In-Vehicle Battery Durability

OICA comments on EVE-41-03

EVE #42 meeting
08. January 2021

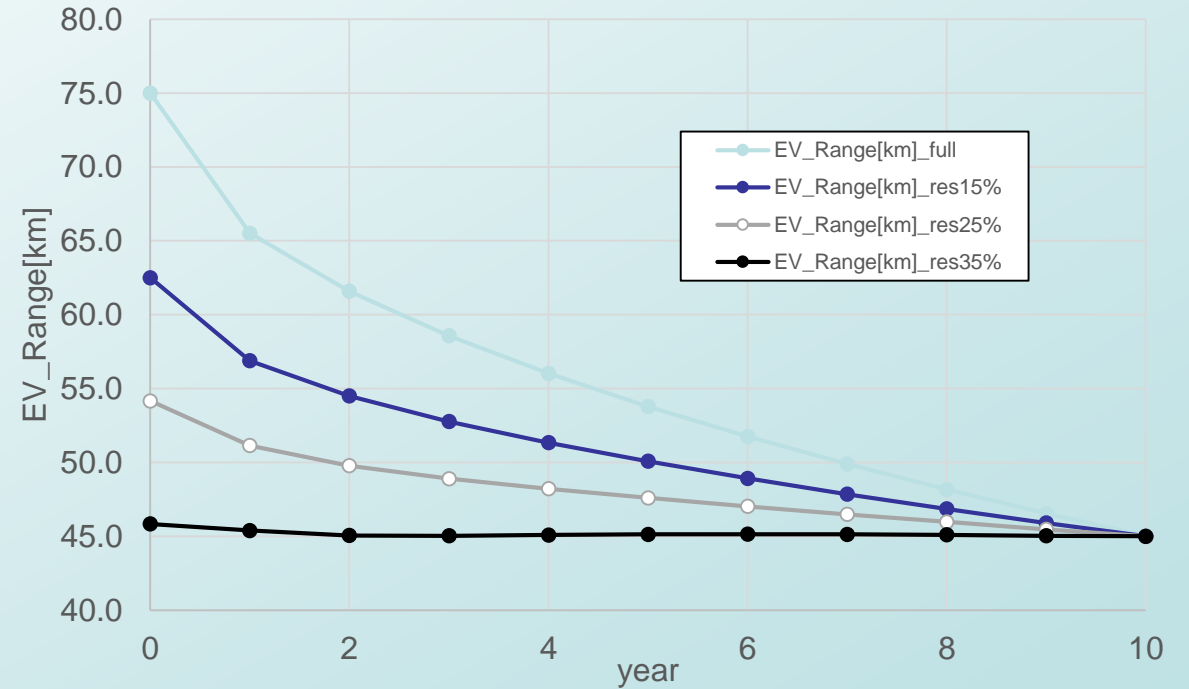
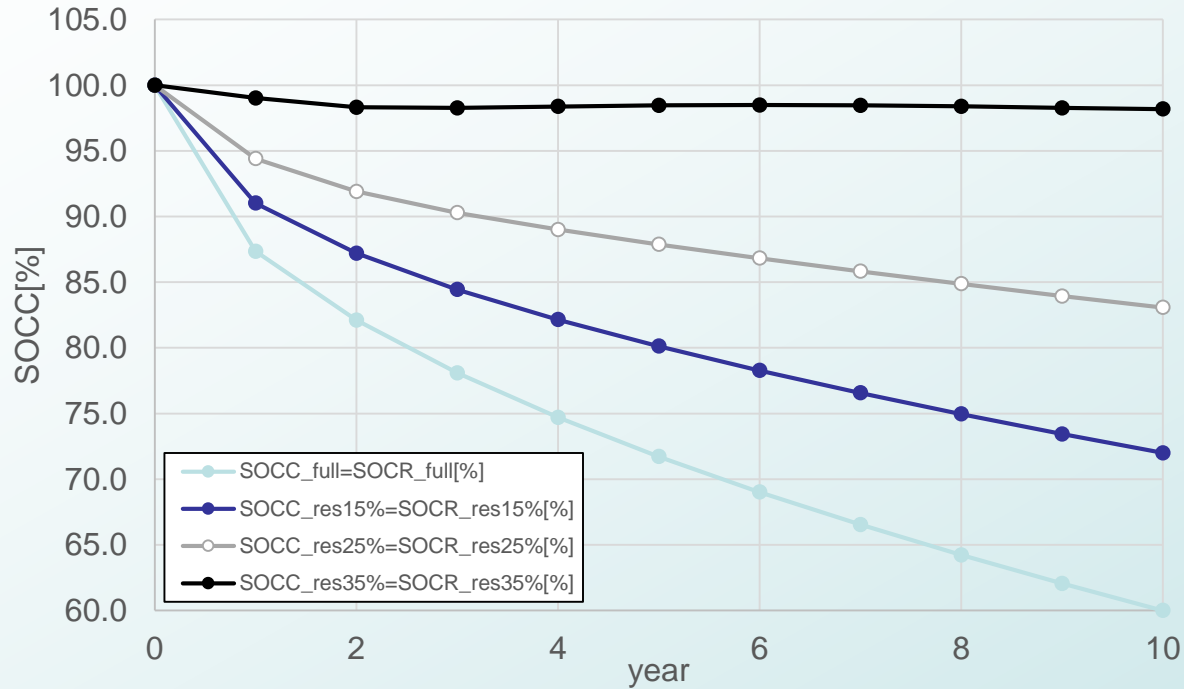
The TEMA model has the clear assumption of a capacity reserve for BEV (15%) and PHEV (25%)

- This values were taken following an oral information of OEMs some years ago but should not be used as basis for setting up the MPR level → These figures can be possible but are not mandatory installed in all vehicles
- Current MPR proposal (based on TEMA) is taking this capacity reserve which means that a capacity reserve for aging effect compensation will become a mandatory requirement

→ Minimum reserve is technically required for purposes like battery protection but not for aging compensation

→ All OEM aiming to keep reserve as small as possible to avoid unnecessary cost, weight and higher consumption

Possible “backstop” concept for MPR structure

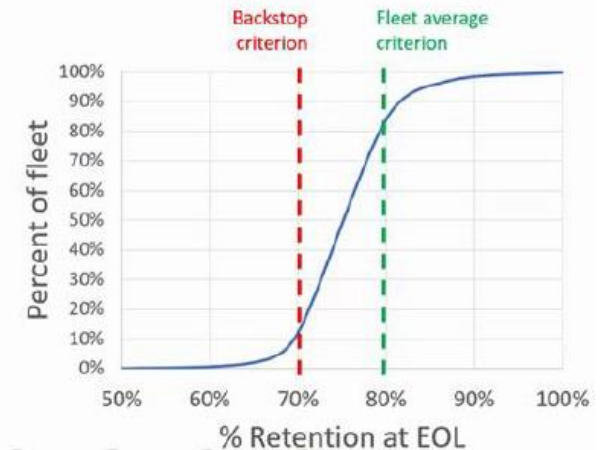
- MPR might consist of fleet average criterion + backstop criterion
- Both must be met. For example:
 - Fleet must average 80% retention
 - AND not more than 10% of fleet can achieve less than 70% retention

- The shape of the curve is critical as at this stage, OEMs don't know the shape of the curve: Different regions, driving profiles, battery chemistry all play into the shape, etc.
 - TEMA model cannot be used for creating the shape of that curve as TEMA still needs further evaluation
- ➔ Phase 1 with implemented SOCC and SOCR should be used to identify the distribution in the field and the shape of the curve

*Source:
Geotabe data
from EVE-41-
03e

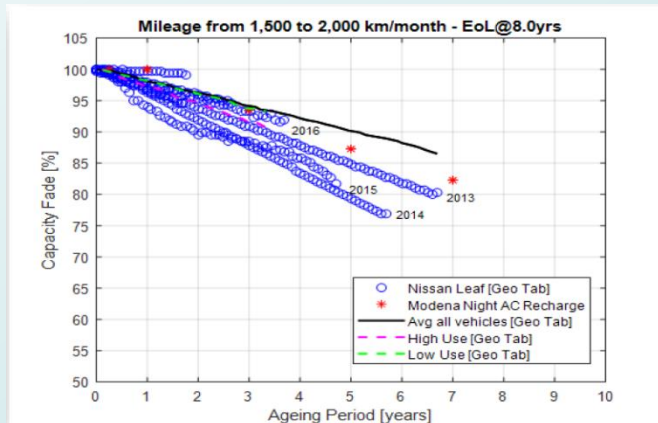
According to the shown GEO tab data in EVE-41, there are cases where the Nissan LEAF does not meet the 5 year 80%.

Does this indicate that proposed MPR judged LEAF as a substandard product to be excluded from the market?

Model construction (EVE-23-08):

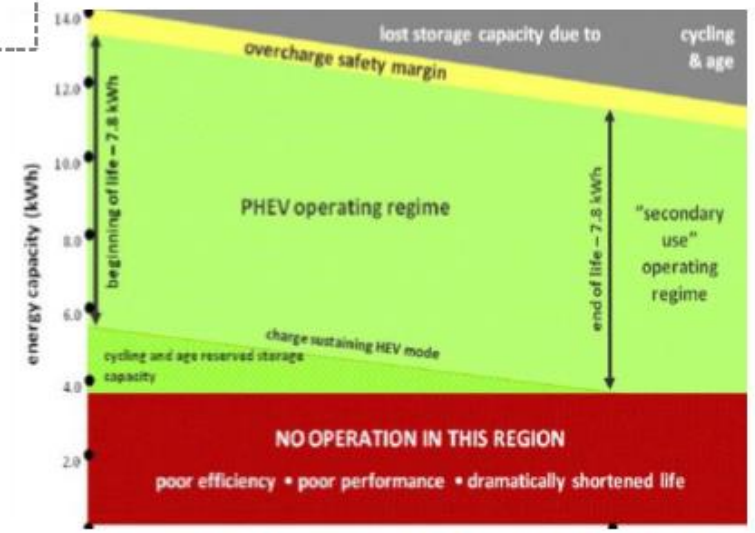
1. What are the input and output parameters in the different modules (1-5)? (To be able to track how parameters are used in the model)
2. What assumptions are made in the different modules) (To analyze error multiplication effects and accumulated errors)

3. Life prediction estimates (year and milage) are outputs from Module 2. How does Module 4 feed back to module 2 for life estimations including e.g. V2G ageing?

4. Please explain the diagram on the right. What does it mean and what is the relevance for the model?
5. GIS and External System interface – is this where the geographic and climatic impact factors are introduced? If yes, then why is this only feeding into Module 3, 4 and 5?

6. Module 5 appears to be associated with ICE operation in PHEV. Is this correct?
7. Usage conditions (e.g., 25% reserve for PHEV and 15% reserve for BEV) and results/sample size (e.g., EVE-30-12e.pdf & EVE-34-16e.pdf data comparison for Nissan Leaf and Tesla) are limited and not representative of how all OEMs may choose to use the battery and how batteries will degrade in the field. Many PHEVs and BEVs use smaller reserve (many of today's BEVs can use <10% reserve).
